ALLOCATION PROBLEMS OF SECOND AND THIRD CHANNEL
FM RADIO STATIONS (LPFM) IN THE VICTORIA,
TEXAS, RADIO MARKET

SUBMITTED AS ADDENDUM TO REPLY COMMENTS
IN RM-9242
BEFORE THE
FEDERAL COMMUNICATIONS COMMISSION

FM STATIONS VERSUS LOW POWER FM STATIONS -- LOSS OR GAIN?

ADDENDUM 21

EXHIBIT E.R.C. (2)

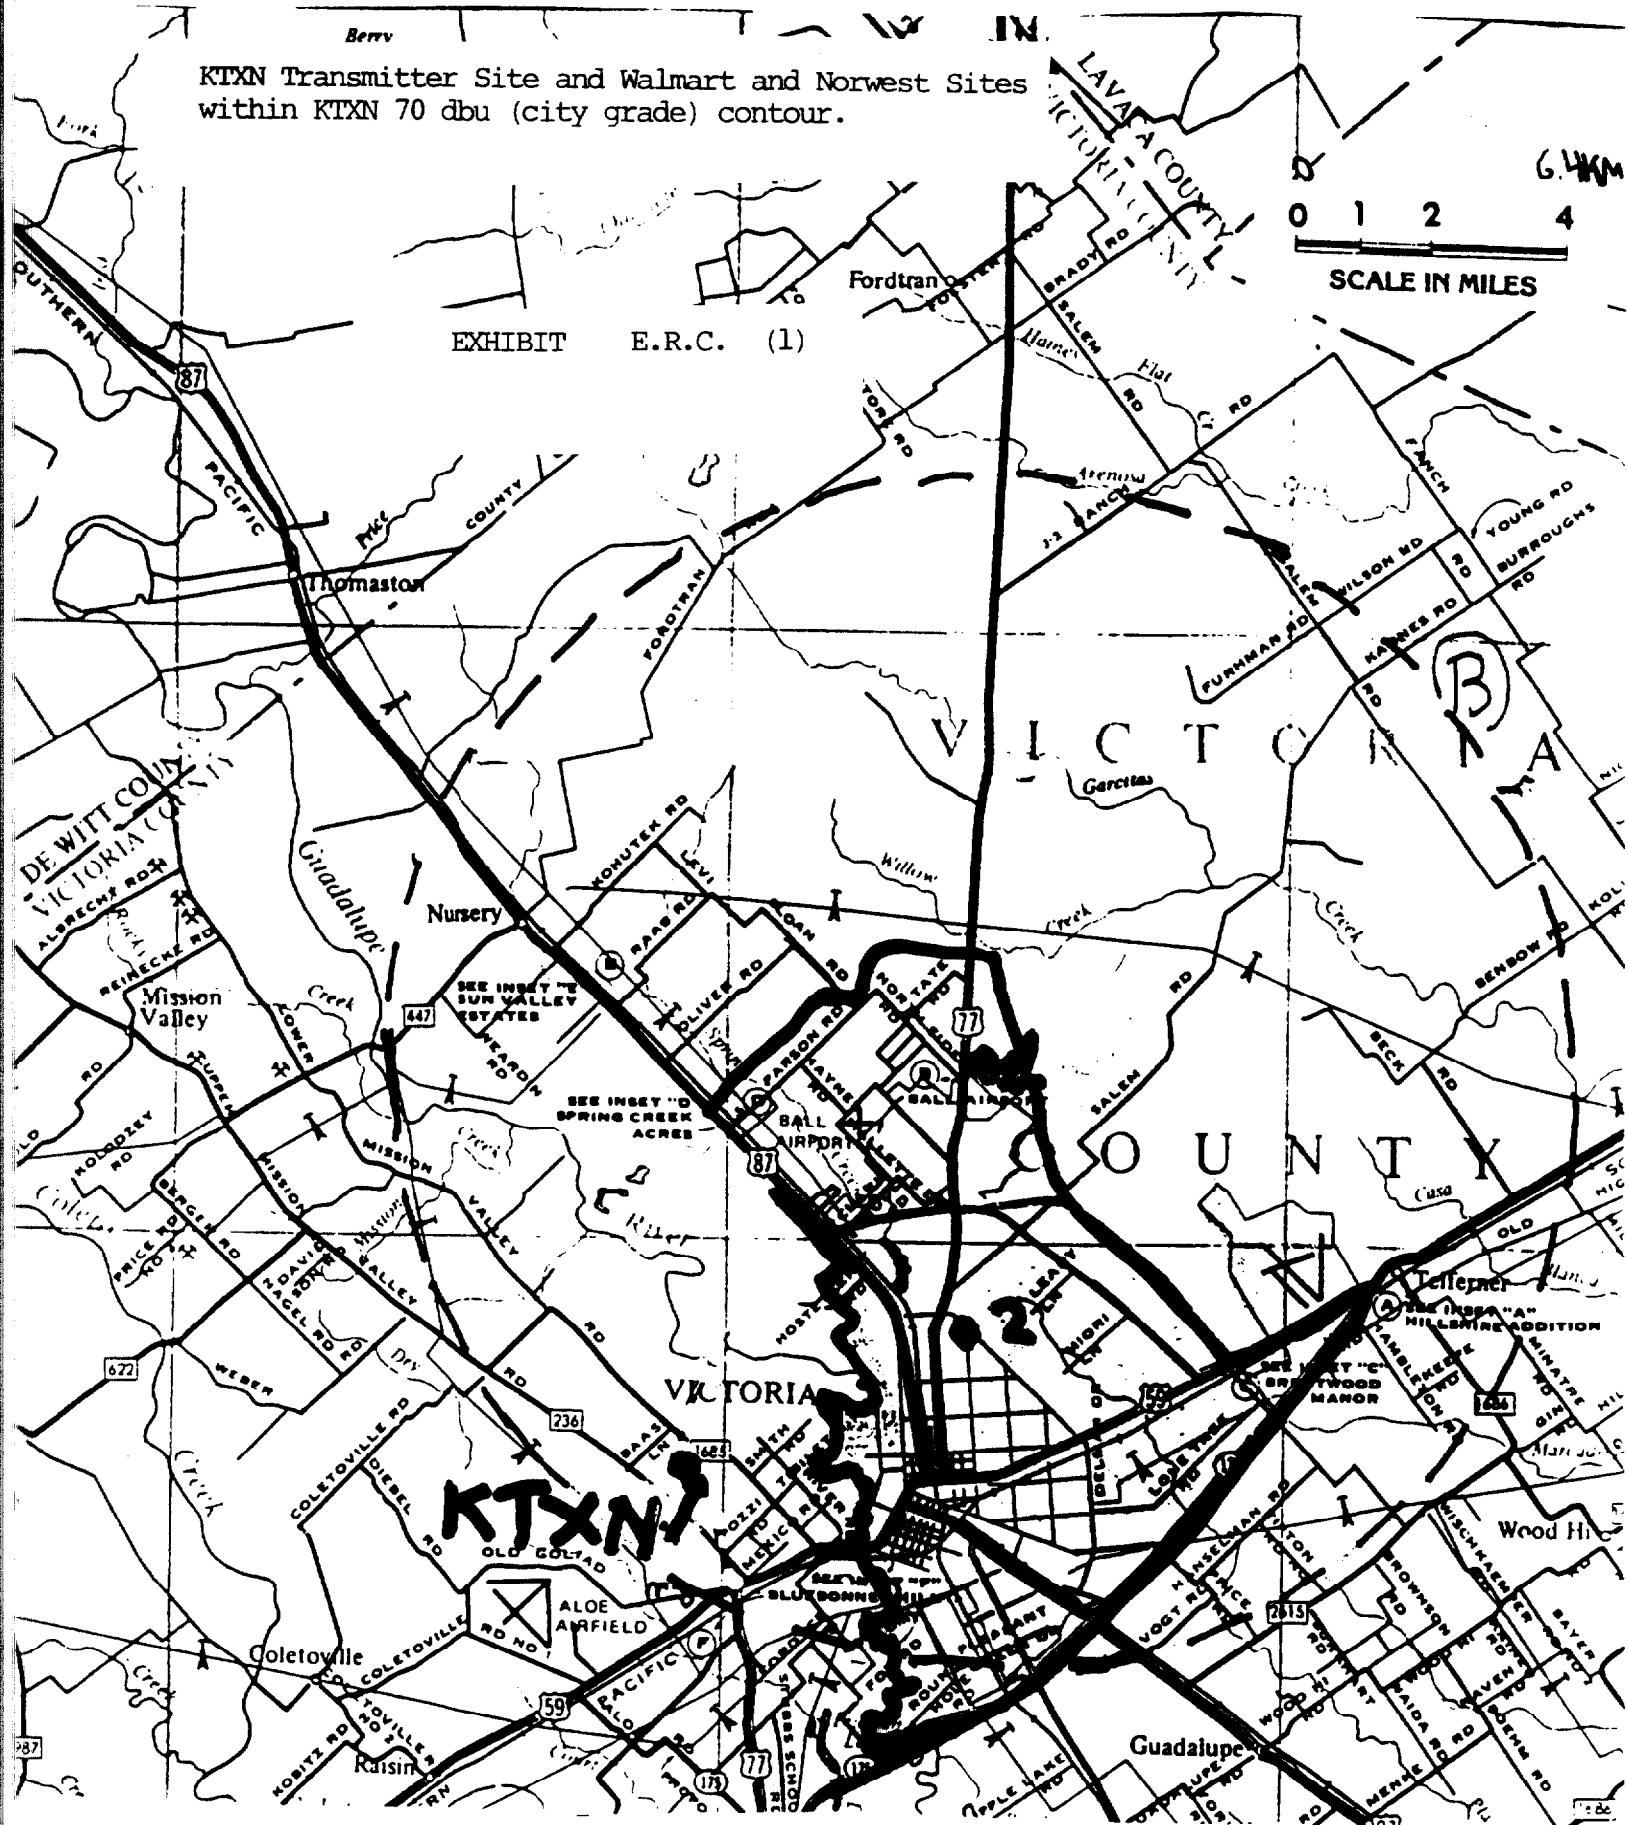
WALMART IMPACT

K_TX_N 60 DBU AREA LOST
1530 Mi² 445 Mi² 29%
3963 KM² 1153 K.M²

EXHIBIT E.R.C. (3)

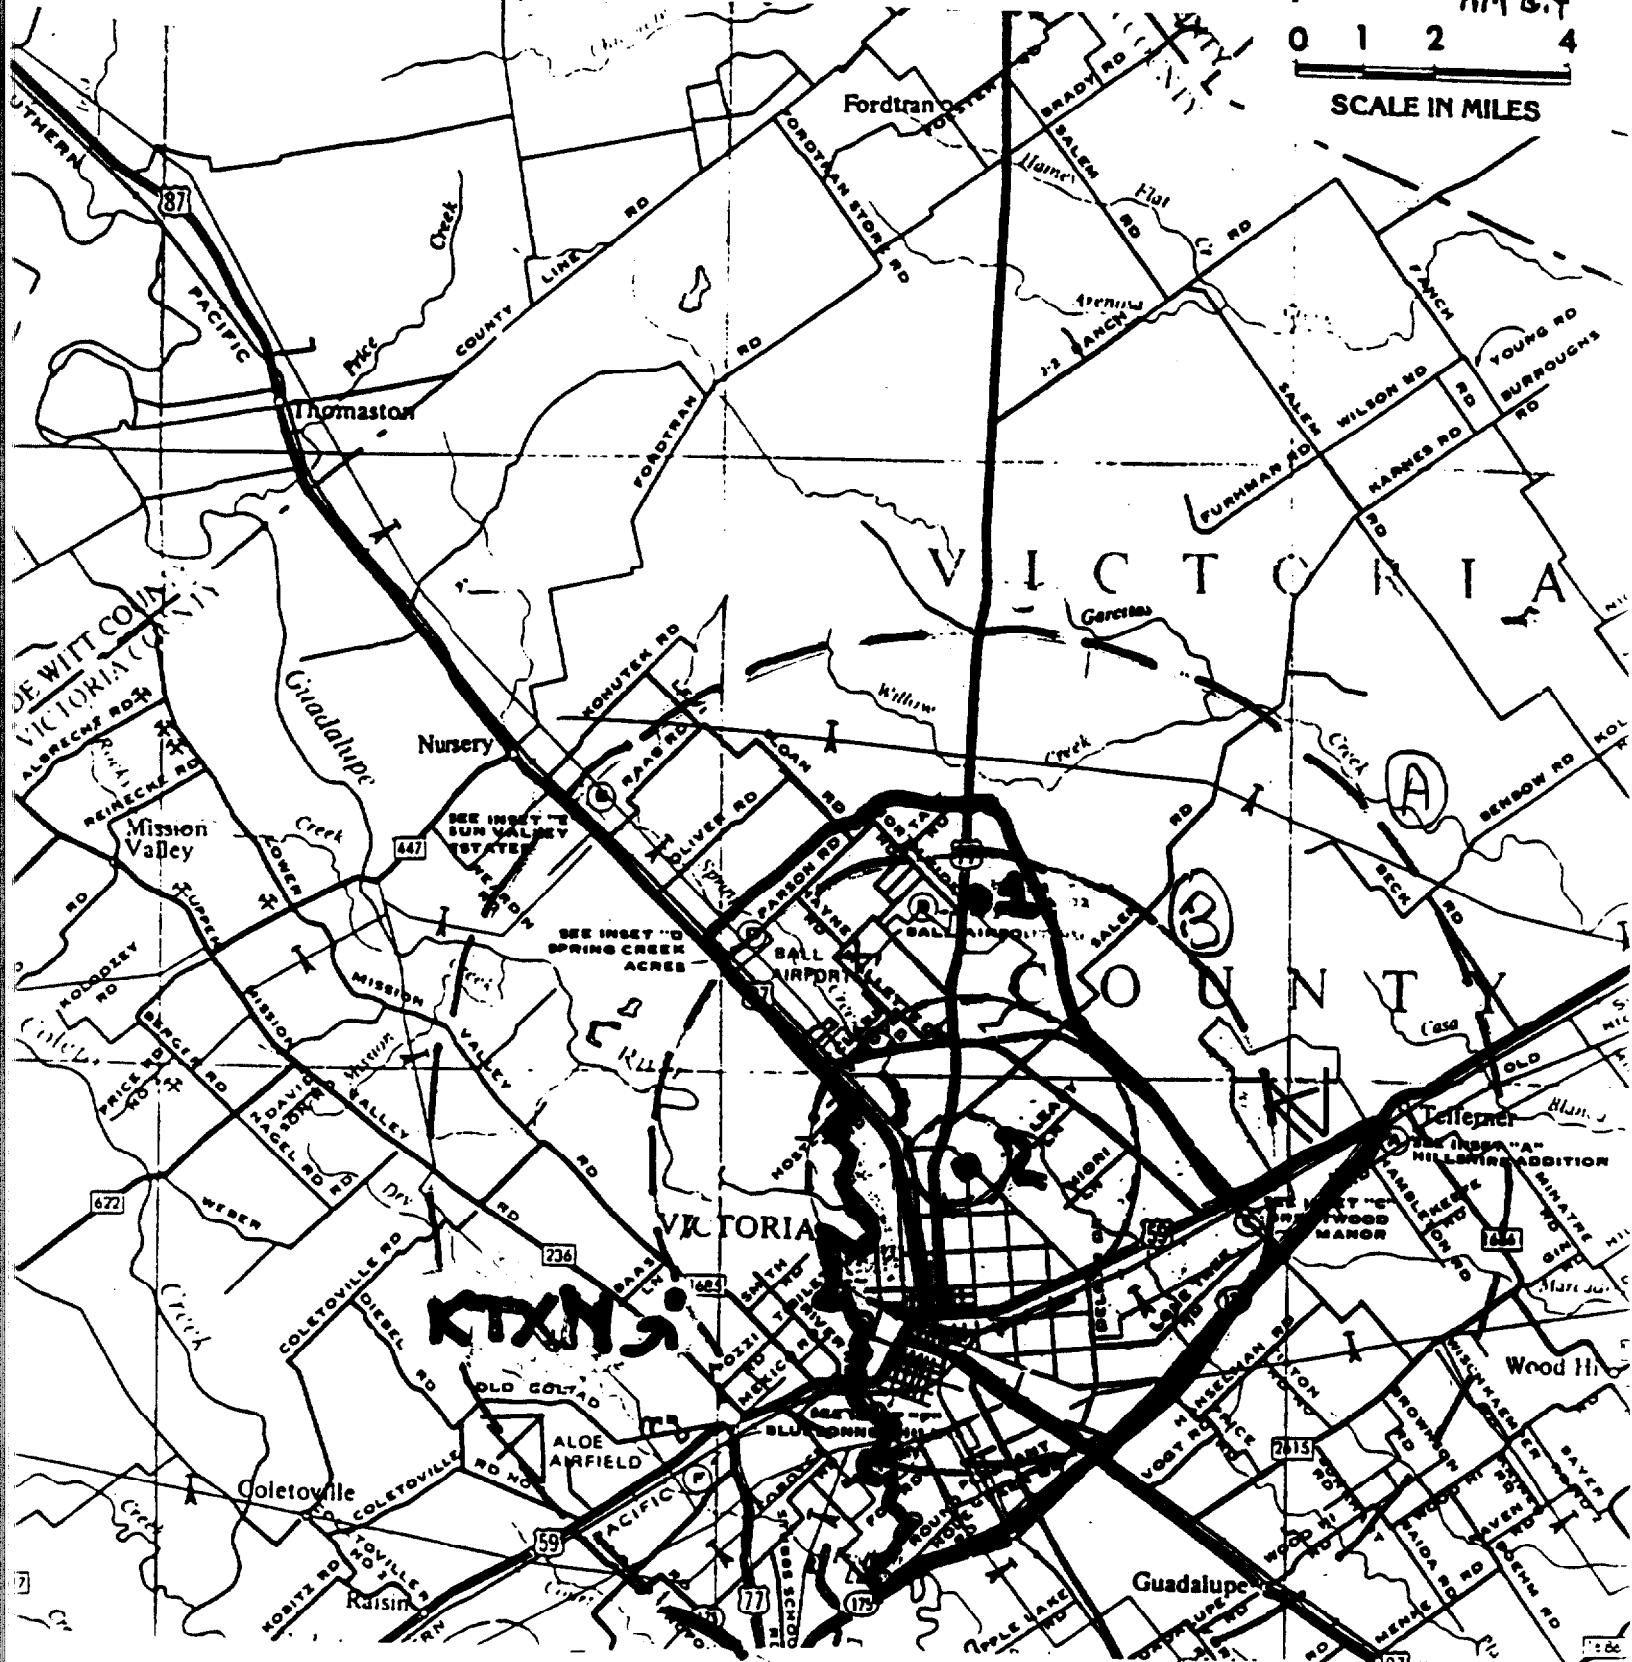
KTXN Transmitter Site and Northwest site
and its 100 , 80, and 70 dbu contours

3 KW 328' (100 m) #1 WALMART 7.3 mi
1 KW 150' (46 m) #2 NORWEST 11.7 KM
4.7 mi

Proposed Edna, Texas, LPFM at 28 Mi (45 km)
at bearing of 65° true. and impact on KTXN
60 dbu contour.

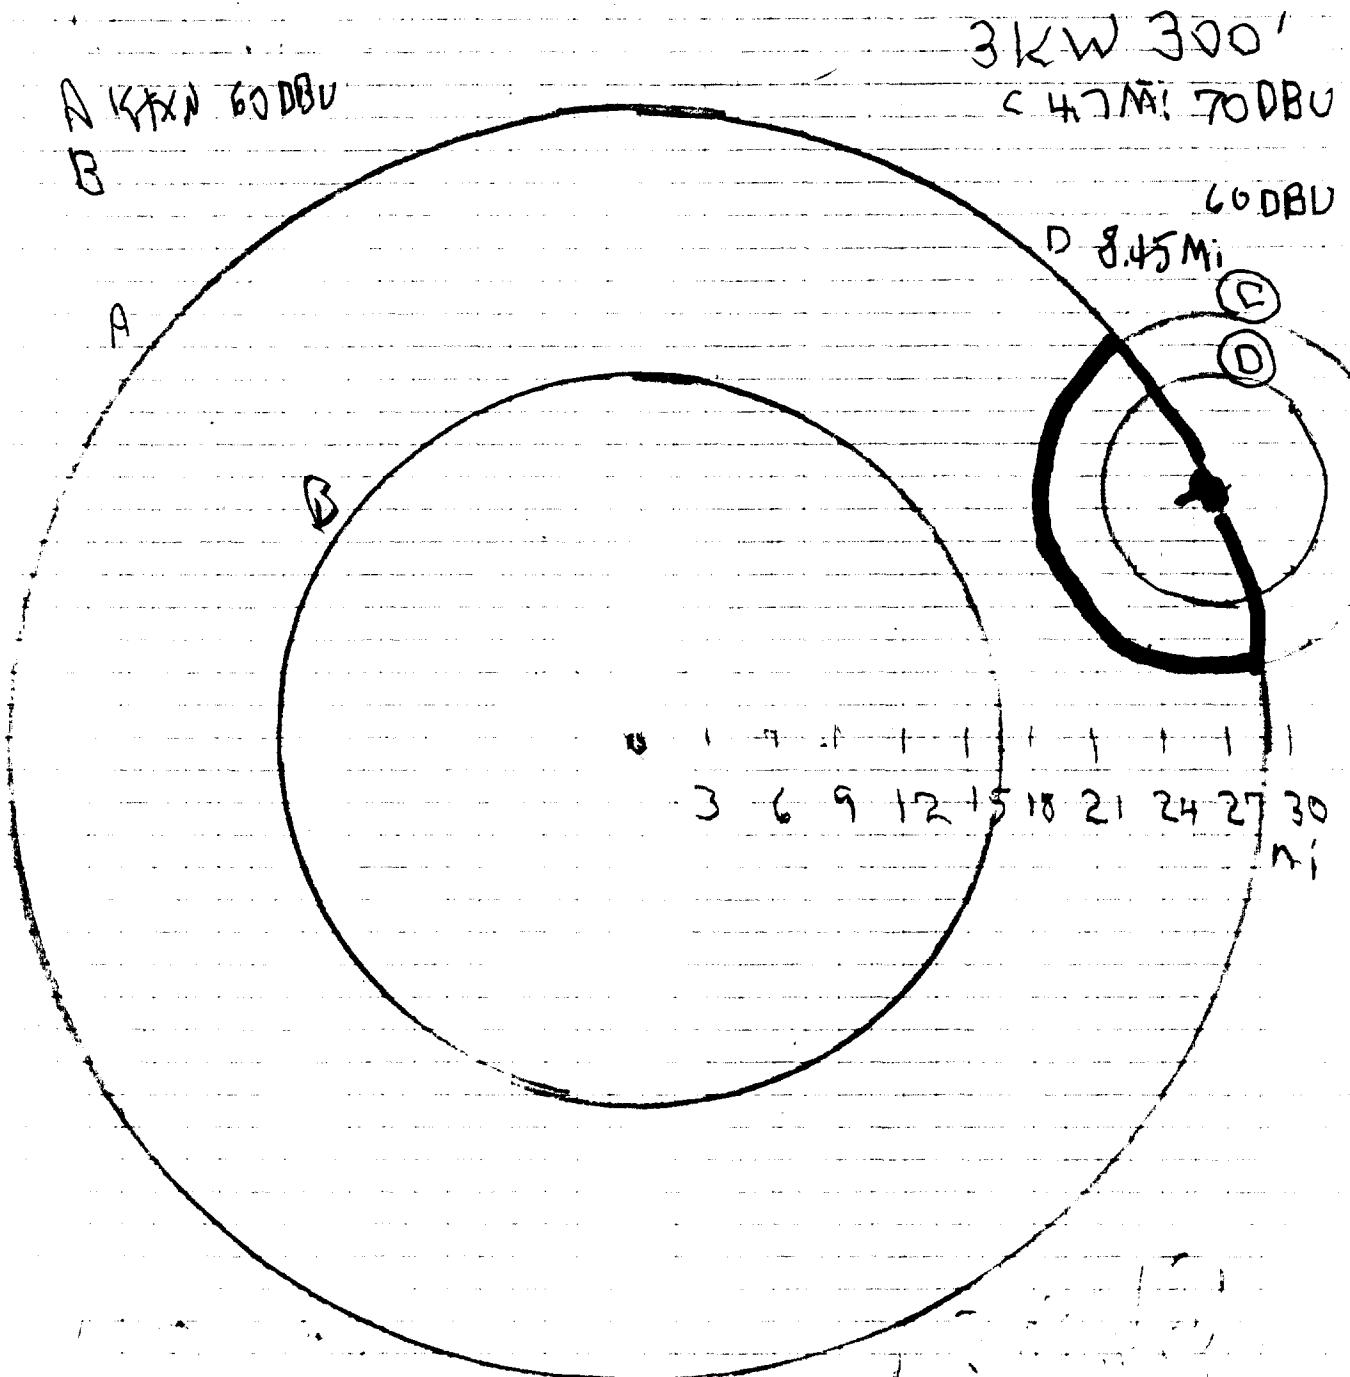
KTXN 60 DBU
2457 Mi²
6368 KM²

LOSS TO KTXN
3.5% - Mi.²
1527 . KM²

LOSS TO EDNA
14.6% 50%

EXHIBIT E.R.C. (7)

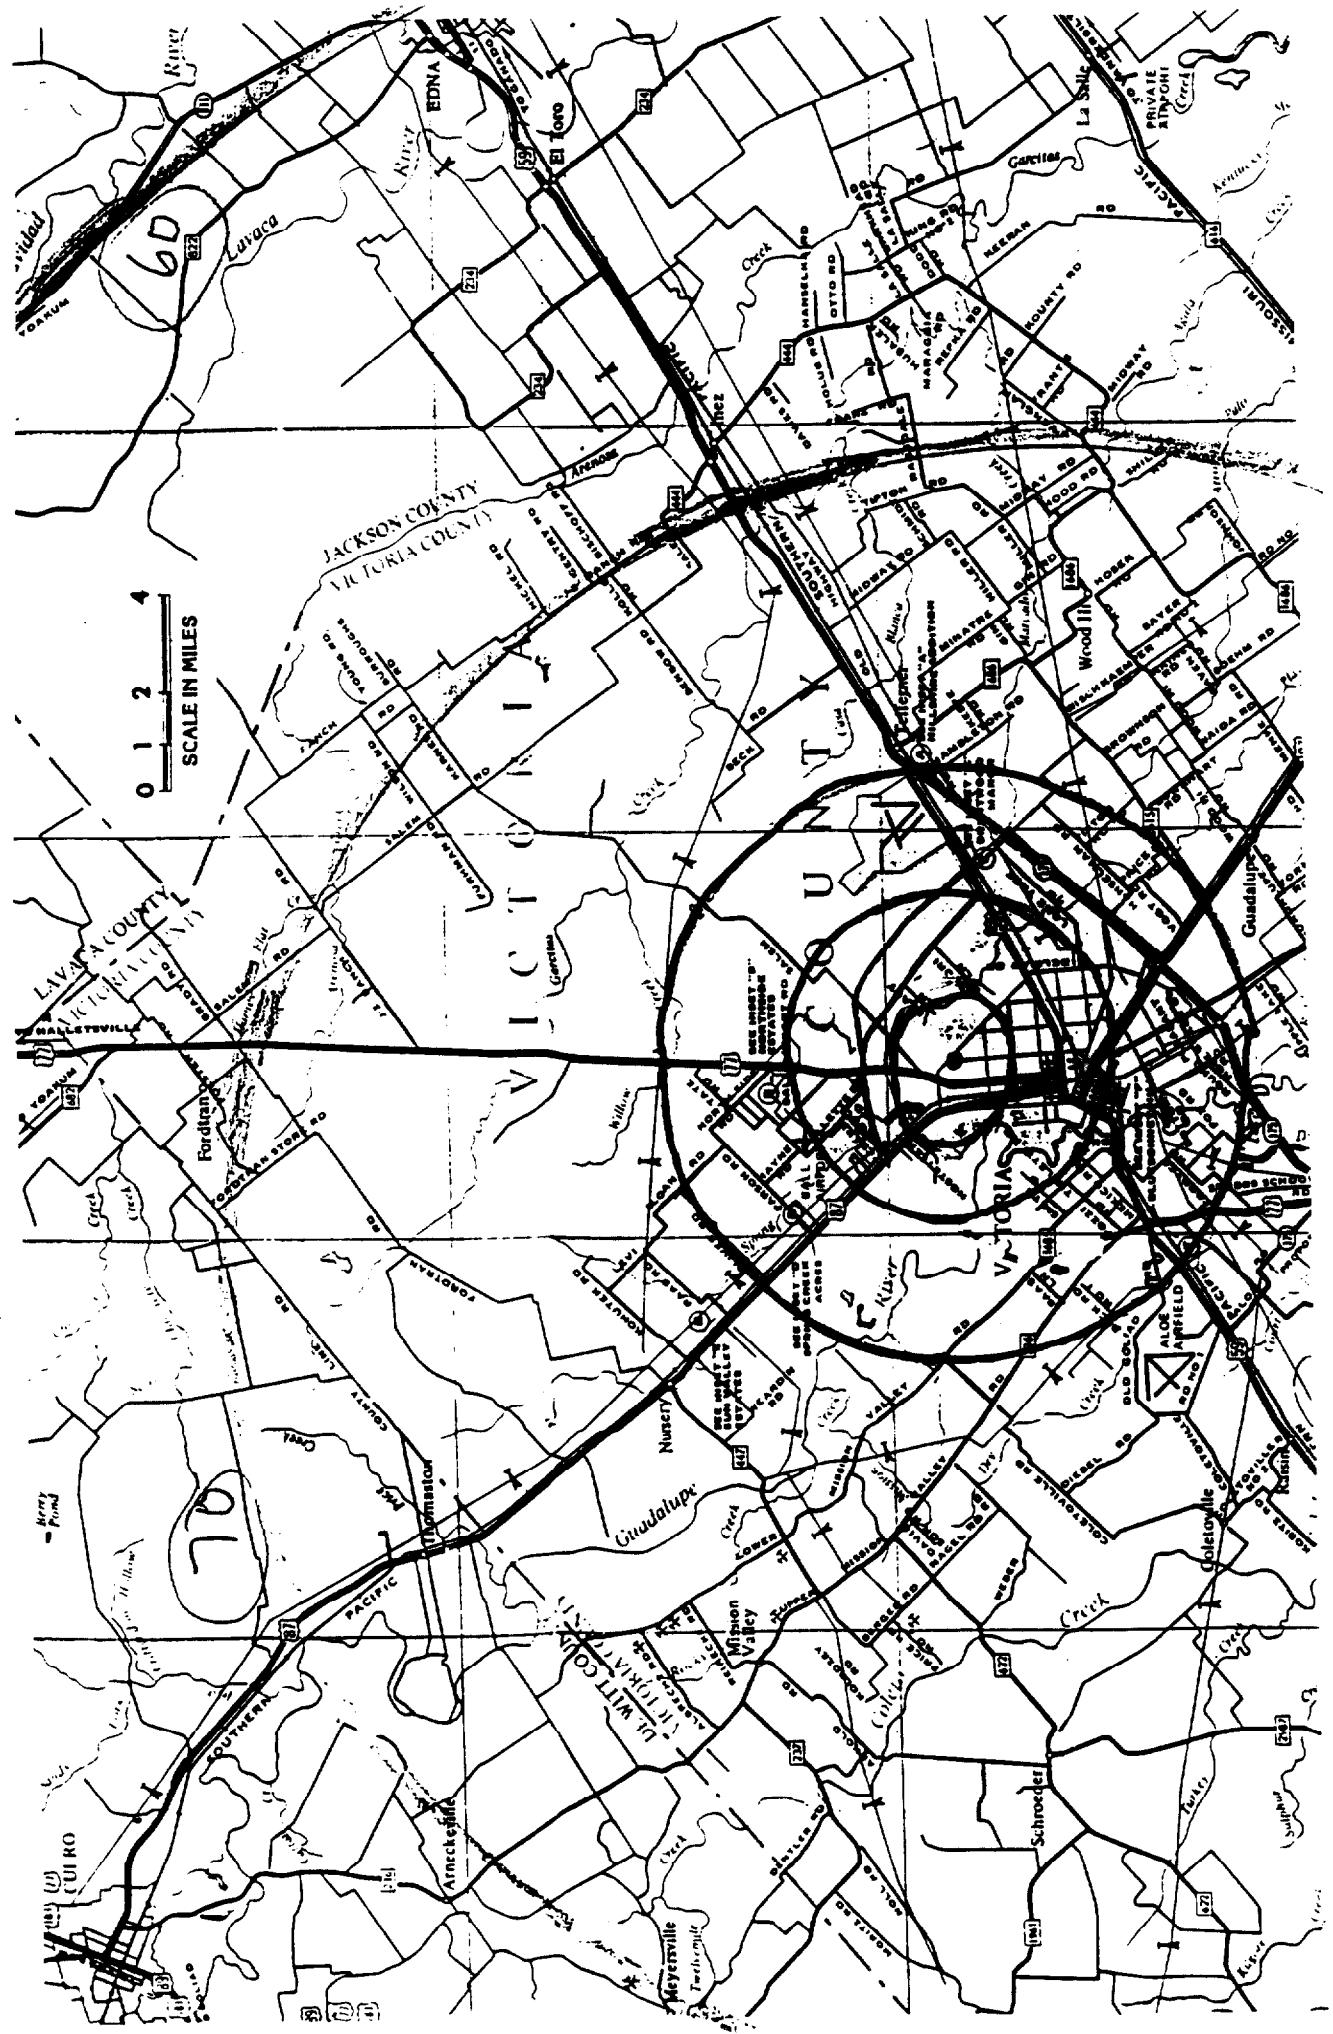
Norwest alternative LPFM 100 watts at 100 feet (32M) coverage contours of 80, 70, and 60 dbu within KTXN 70 and 60 dbu contours.
